Bulletin No: 11KARTHAIR
Release Date: 05-16-2011
Effective Date: 05-16-2011
Supersedes: N/A
Completion Date: See text
Page: 1 of 1

SAFETY ALERT

Ride Name: Go-Kart

Model: Eagle, Double Eagle, Talon

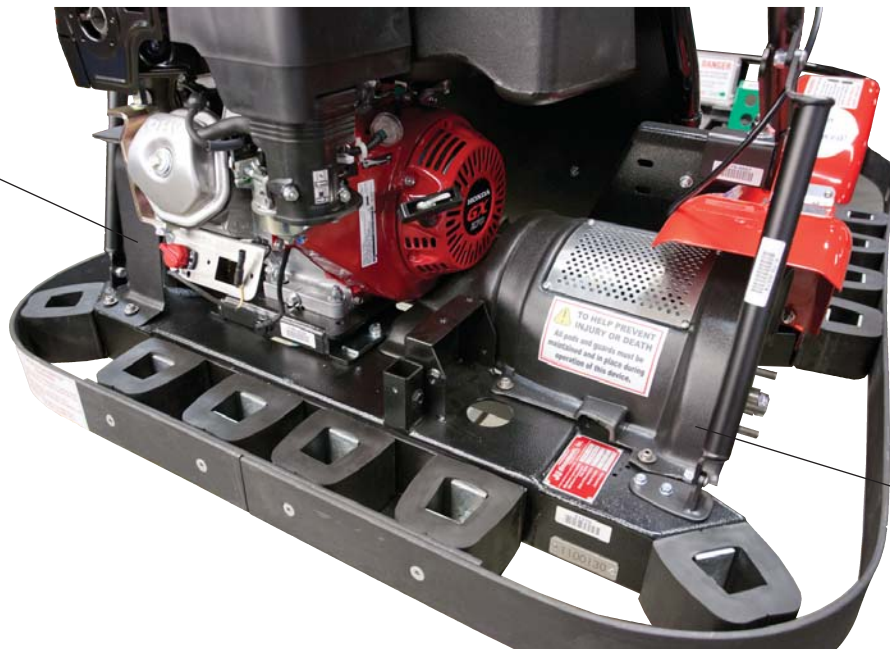
Drive Pulley/Axle cover installation to be performed by owner at owners expense.

Long hair or loose clothing being caught in rotating parts.

To reduce the risk of un-restrained long hair or loose clothing becoming entangled in rotating parts.

Installation of J&J Drive Pulley/Axle Cover Kit

Eagle & Talon (#1-60-A3010), Double Eagle (#1-60-A3011)

Contact J&J Amusements, Inc. for documentation regarding installation of Drive Pulley/Axle cover kit. Refer to Service Bulletin number on this document.
